SUNDRY NOTICES AND REPORTS ON WELLS
Do not use this form for proposals to drill or to re-enter an abandoned well. Use form 3160-3 (APD) for such proposals.

8. Well Name and No.
HOWELL COM J 301

PLUG AND ABANDONMENT PROCEDURE

CONDITIONS OF APPROVAL

Proposed P&A

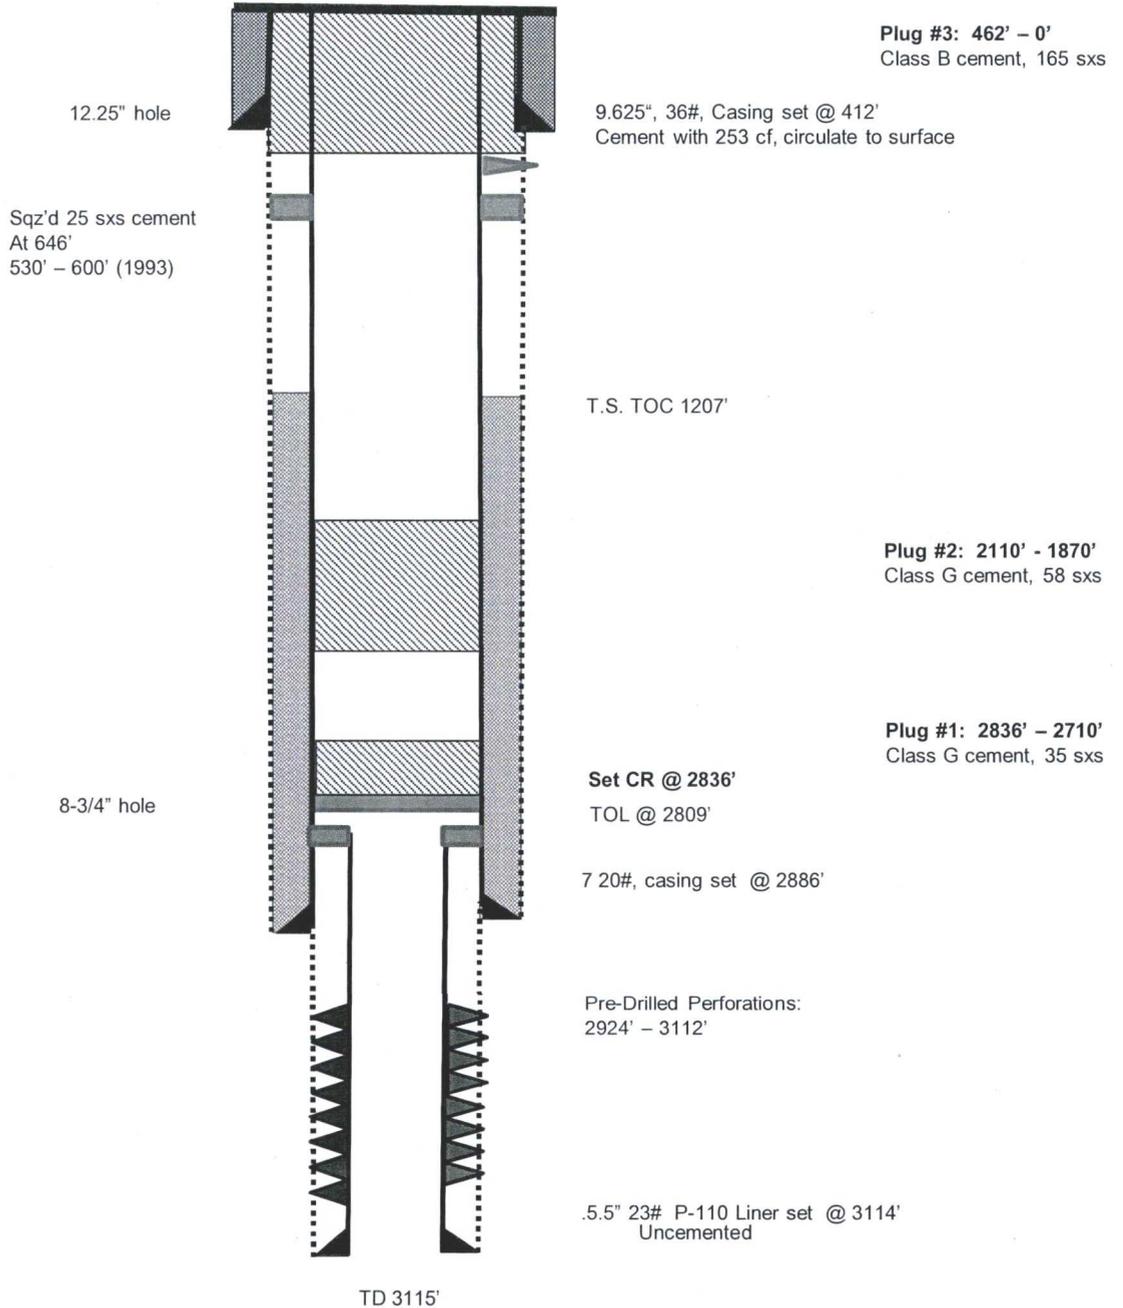
- a) Set Plug 2 (2107 – 1816) ft. to cover the Kirtland and Ojo Alamo tops. BLM picks top of Kirtland at 2057 ft. BLM picks top of Ojo Alamo at 1866 ft.
- b) Set Plug 3 (590 – 0) ft. to cover the Nacimiento top. BLM picks top of Nacimiento at 540 ft.
